# Access Compliance Report

## Public Rights-of-Way

### (Curb Ramps)

Intersection ID: 53339	Main Street: NORTHLAKE CENTRE PY	Cross Street: CALHOUN ST	Location: NW
ADA ID: ED004504EA26	Ramp Type: BlendTrans1	Initial Pass/Fail: Fail	Overall Compliance: No
Codes/Mitigation Info/Possible Solution		Field Measurements/Component Compliance	
Severity Score: 8.75

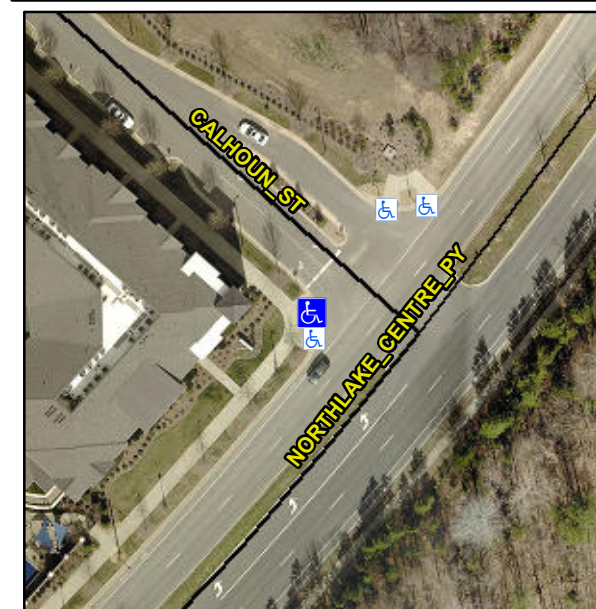
Compliance	Description	Data	Compliance	Description	Data
N/A	Ramp Length (in)	95.0	Yes	BlendTrans Slope (%)	1.9
No	Ramp Width (in)	46.0	Yes	BlendTrans XSlope (%)	0.2
N/A	Flare Type LT	N/A	N/A	Flare Type RT	N/A
N/A	Flare Slope LT (%)	N/A	N/A	Flare Slope RT (%)	N/A
N/A	Flare Traversable LT?	N/A	N/A	Flare Traversable RT?	N/A
N/A	Landing Length (in)	N/A	N/A	DWS Provided?	N/A
N/A	Landing Width (in)	N/A	N/A	DWS Contrast?	N/A
N/A	Landing Slope (%)	N/A	N/A	DWS Length (in)	N/A
N/A	Landing X Slope (%)	N/A	N/A	DWS Full Width?	N/A
N/A	Landing Curb? (Y/N)	N/A	N/A	DWS Offset (in)	N/A
N/A	Shared Landing?	N/A			
N/A	Gutter Ponding?	N/A	N/A	Gutter Slope (%)	N/A
N/A	Gutter Lip Ht (in)	N/A	N/A	Gutter X Slope (%)	N/A
N/A	Painted X Walk1?	No	N/A	Painted X Walk2?	N/A
	X Walk 1 Direction	To NE		X Walk 2 Direction	N/A
	X Walk 1 Width (in)	N/A		X Walk 2 Width (in)	N/A
	X Walk 1 Slope (%)	3.1		X Walk 2 Slope (%)	N/A
	X Walk 1 X Slope (%)	0.2		X Walk 2 X Slope (%)	N/A

N/A	Ramp inside XWalk1?	N/A	N/A	Ramp inside XWalk2?	N/A
	Road Slope (%)	0.2		Clear Space?	N/A
	Road X Slope (%)	3.1	N/A	Clear Space to XWalk (in)	N/A
N/A	Any Obstructions?	N/A	N/A	Storm Grate/Utility Hazard?	N/A
	Obstruction Type			Storm Grate/Utility Type	
		N/A			N/A
			Yes	Surface Condition? (G/P)	Good
			N/A	Curb Slope (%)	0.5

**Remove & Replace Curb Ramp With Two New Directional Ramps or Equivalent.**

**R304.5.1**
